Architect's Supplemental Instructions

Wilma P. Mankiller Health Center
Expansion
Stilwell, OK

ASI Number: Bid Package 02 ASI 006

Construction Documents – ASI 06 – Wilma P. Mankiller Health Center Expansion

SHEET NUMBER: A2.03

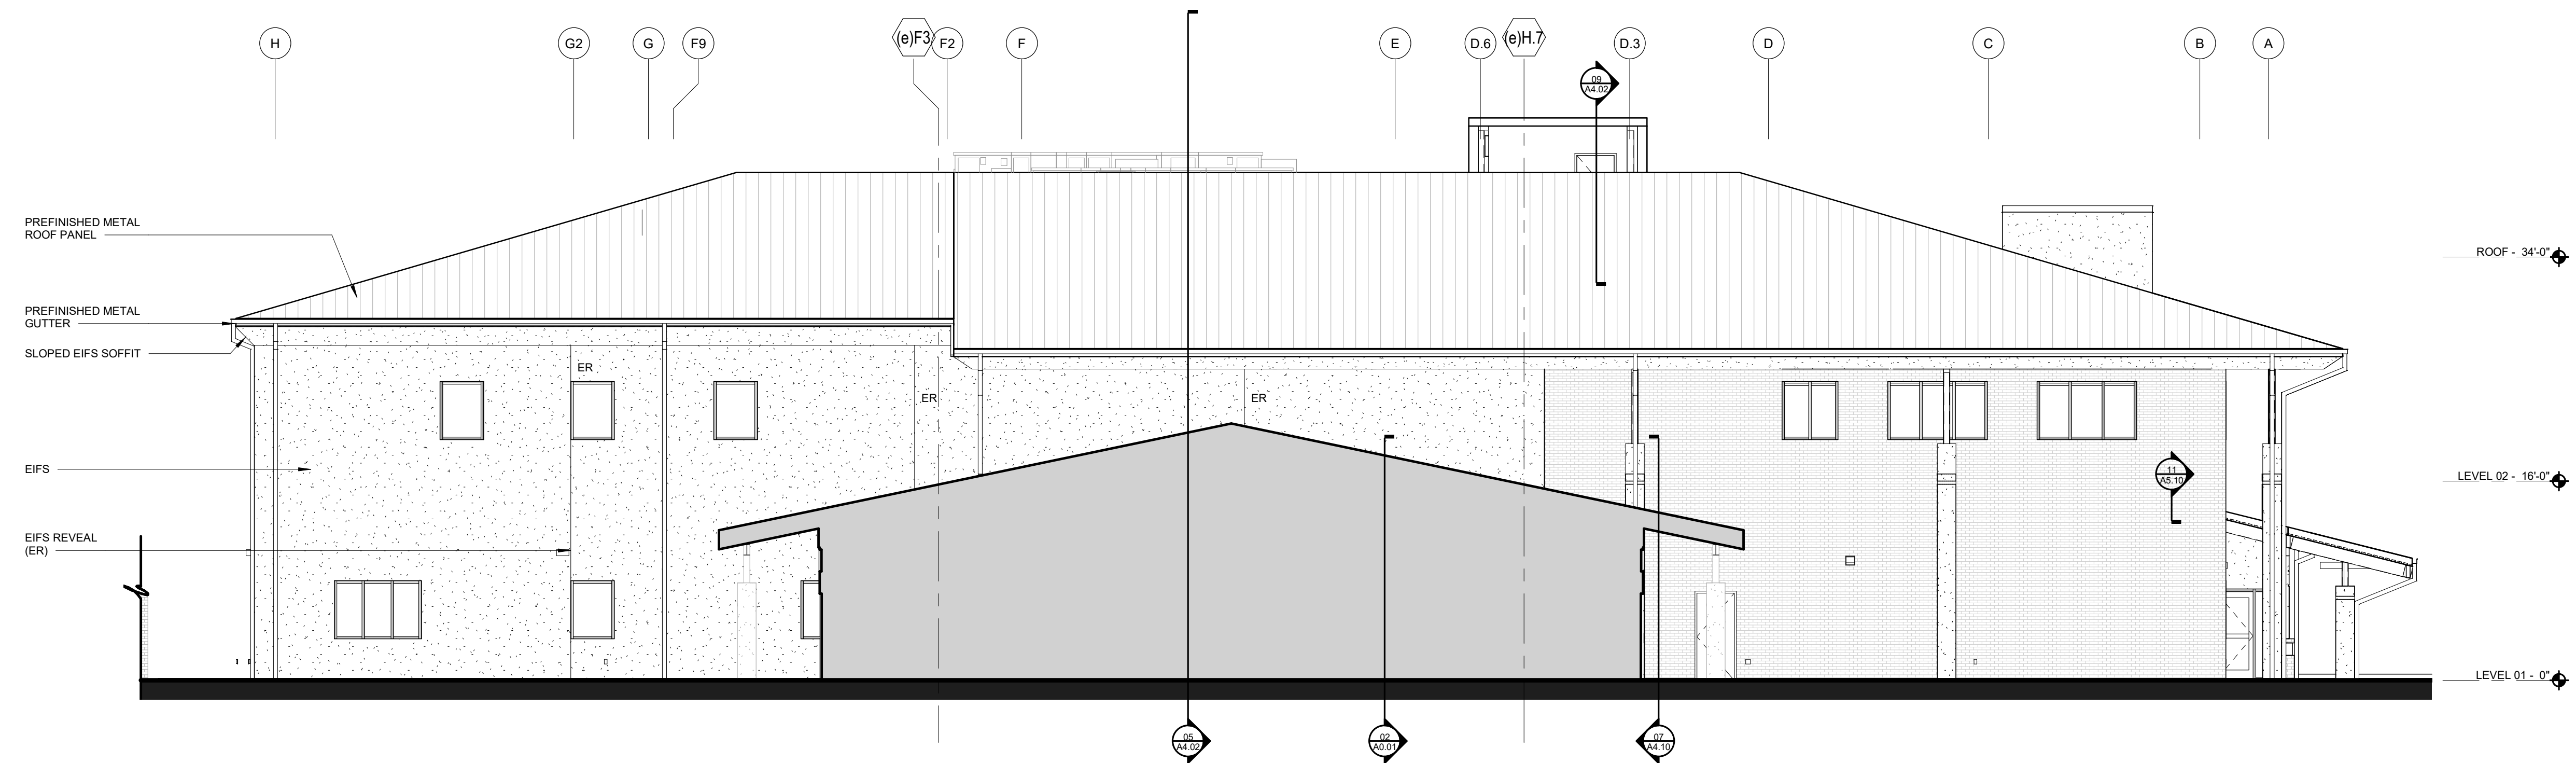
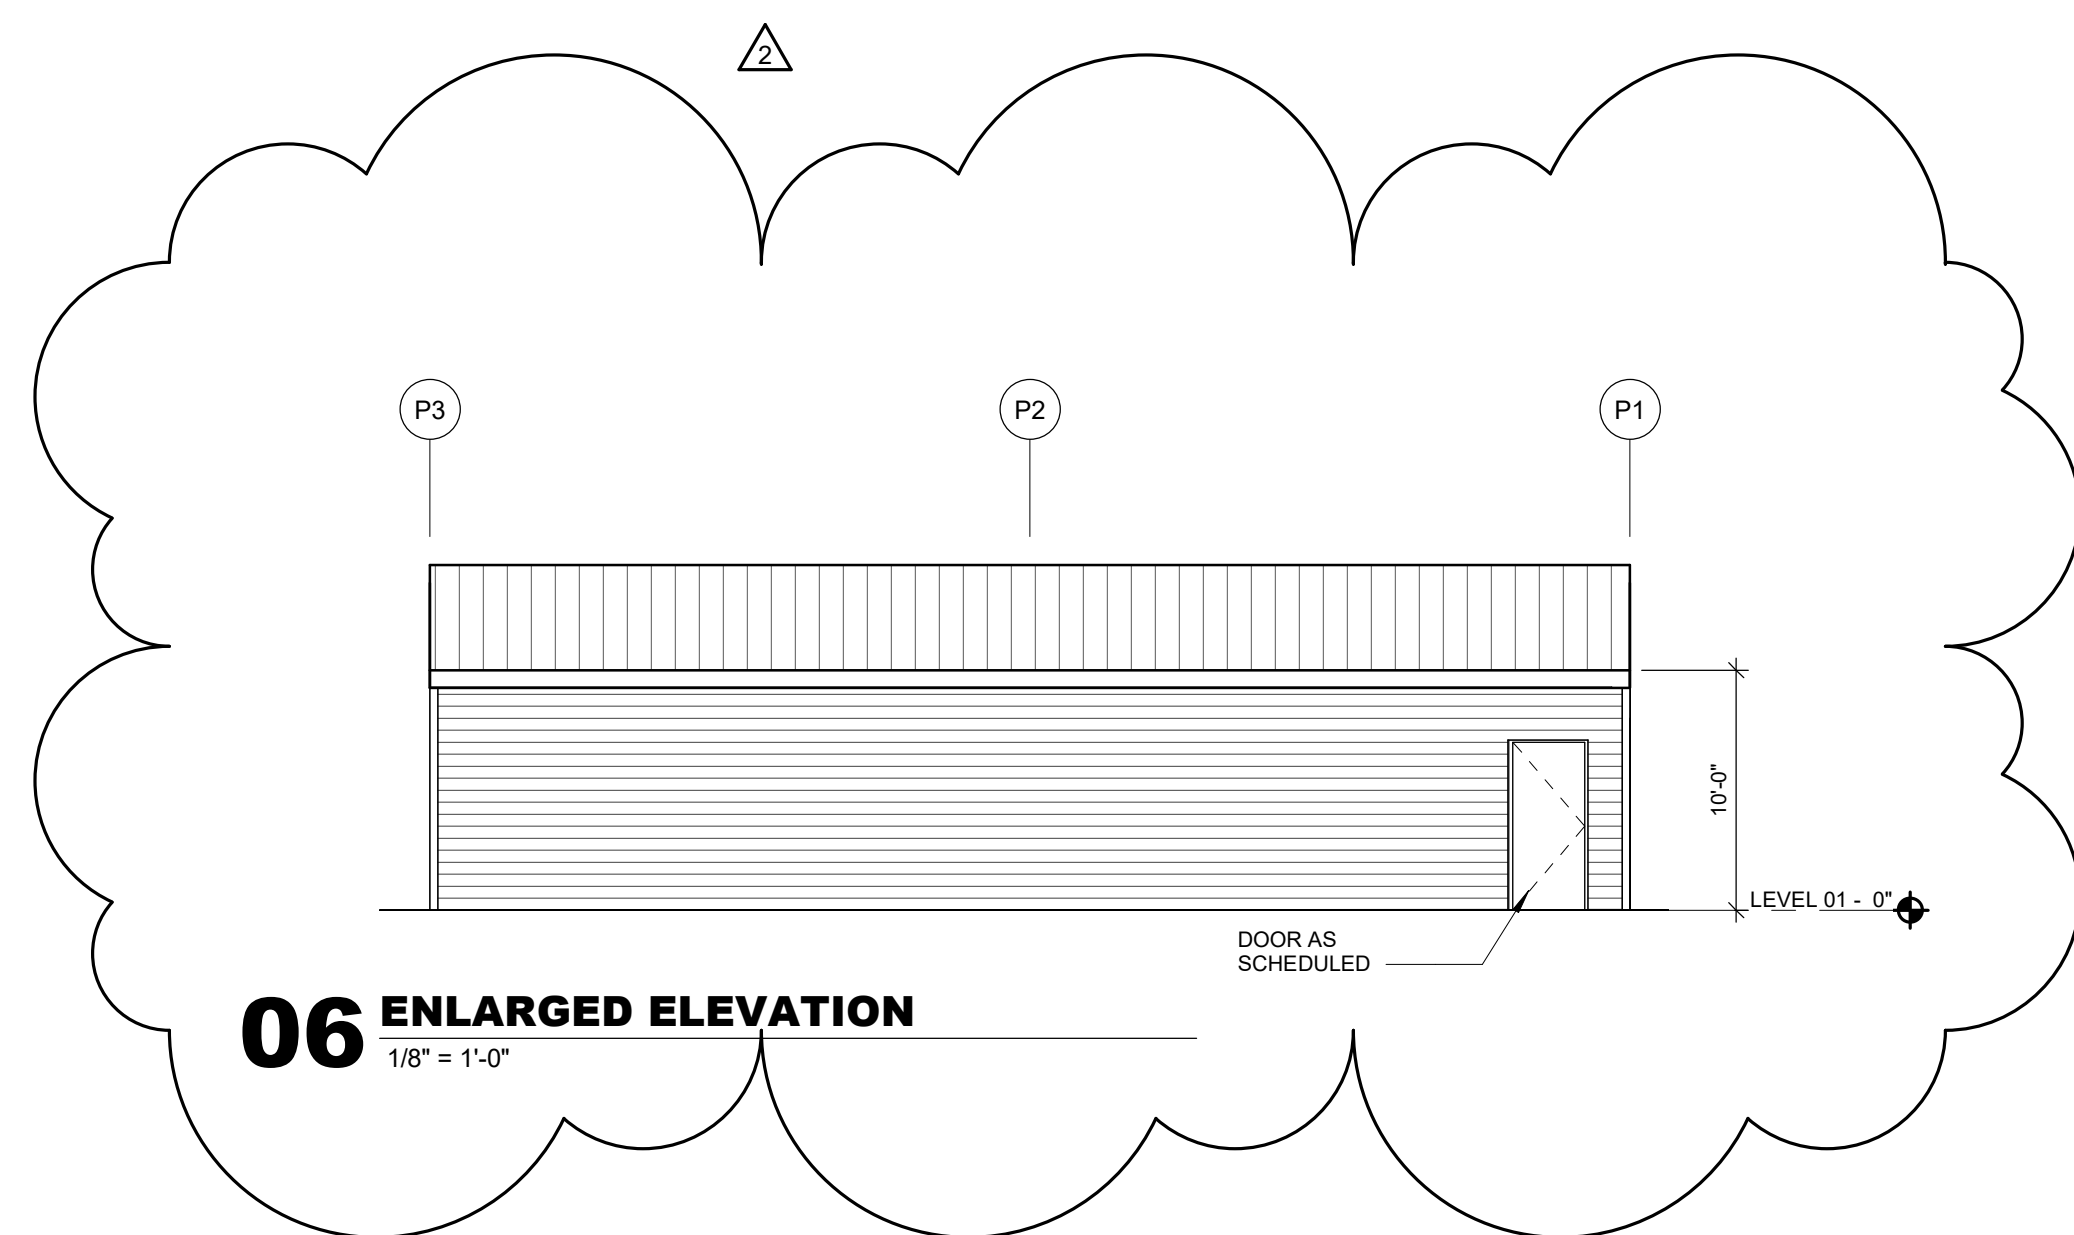
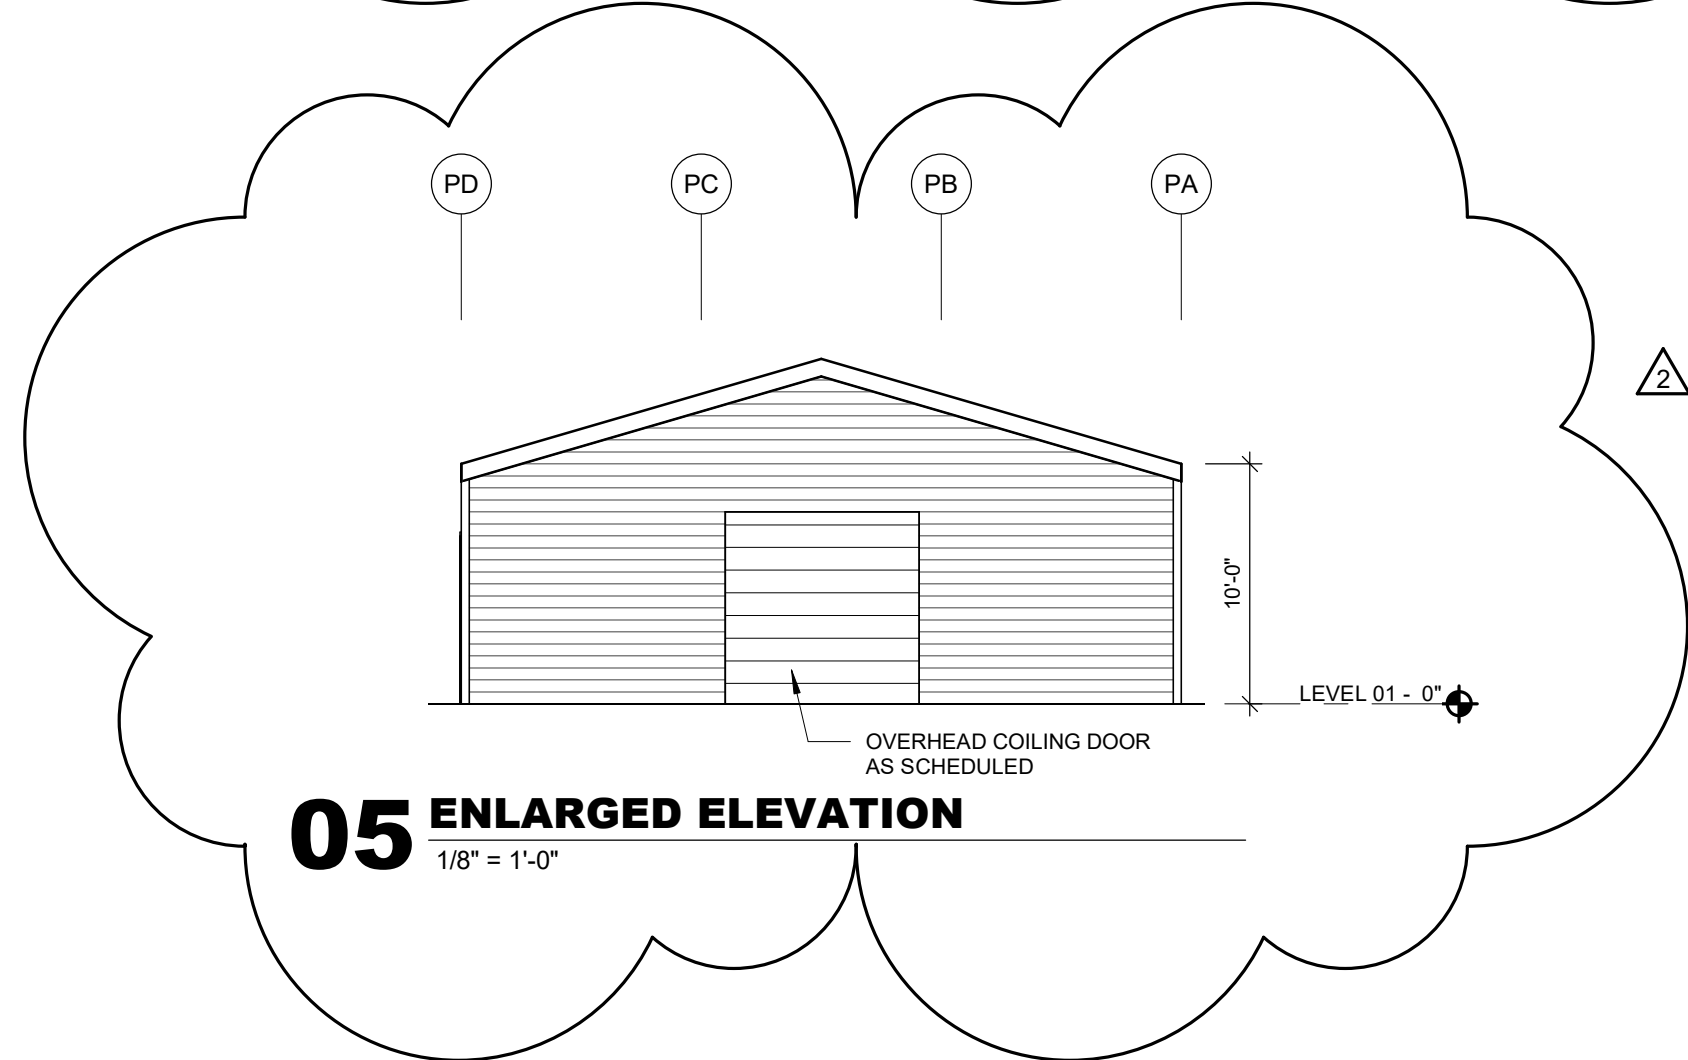
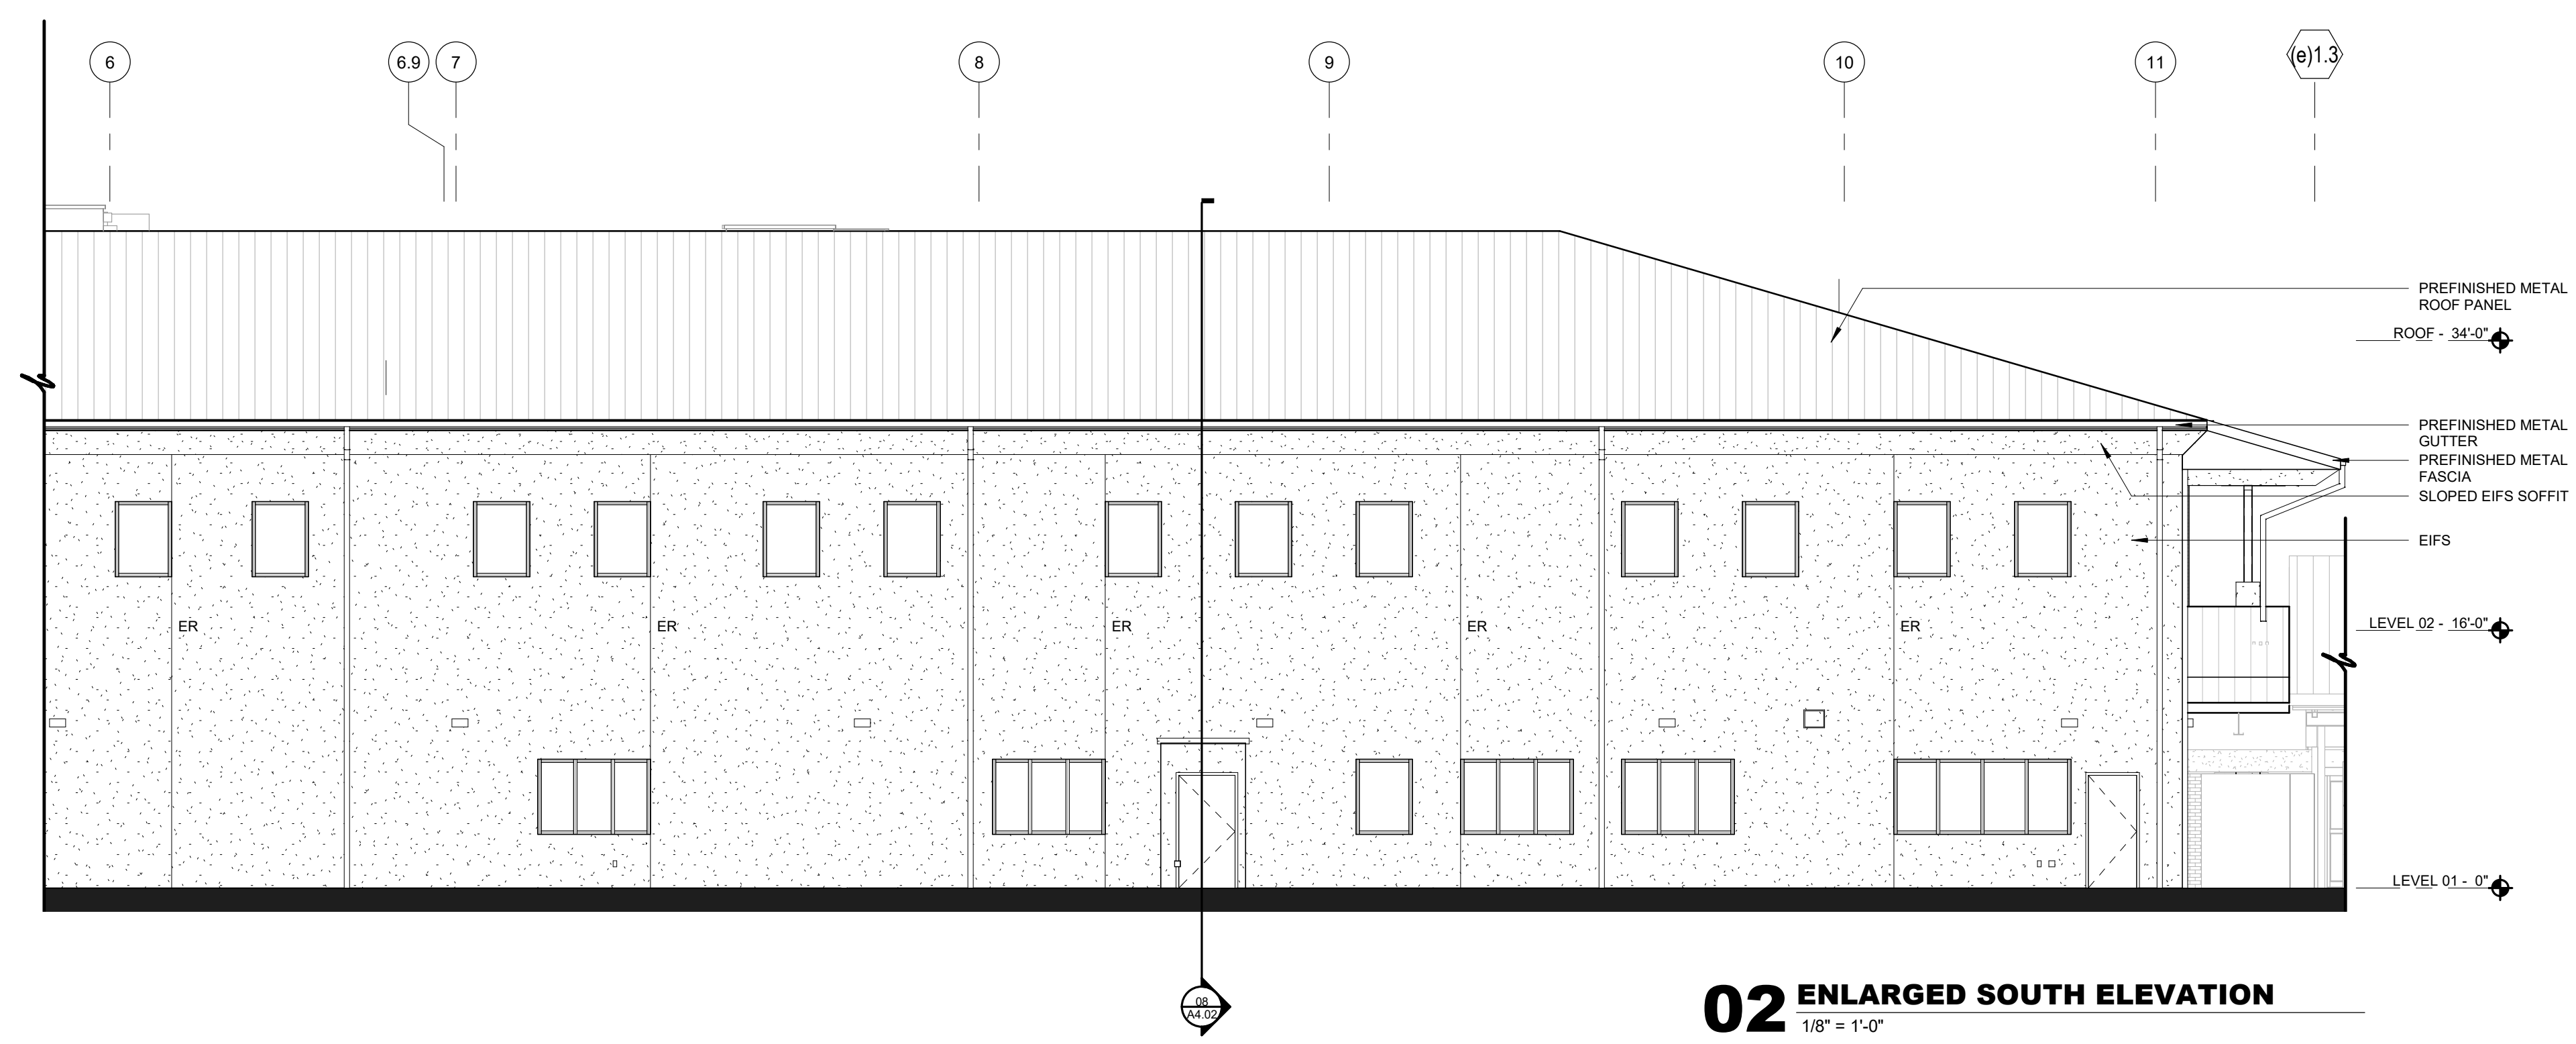
A2.03

1. Enlarged Elevations added
